MEETING ON MIDLAND 1&2 PROPOSED HIGH ENERGY LINE BREAK ANALYSIS

On May 21 Consumers Power Company met with the NRC Staff in Bethesda to discuss proposed High Energy Line Break Analysis (HELBA) for the Midland Units. The Agenda for the meeting (attached) appeared of sufficient interest to ACRS that, with Mr. Libarkin's concurrence, I attended.

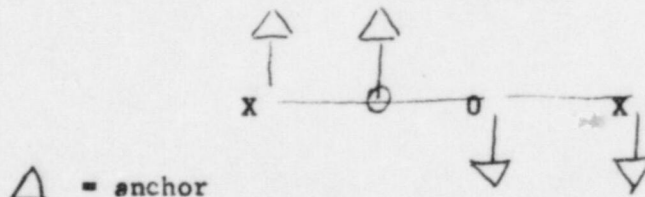
A system may have four anchor points or terminal ends; breaks are postulated there. The following example was used:

Break at each of anchors and anywhere stress exceeds .8 (No where)

X - assume break at elbows

Regulatory Guide 1.46 may require break at terminal O, but this Tee does not act as a restraining point since there is no anchor there.

The NRC Staff indicated they would have no problem with not postulating a break at this point provided a detailed stress analysis is done at this point to show that no stress limits are exceeded.
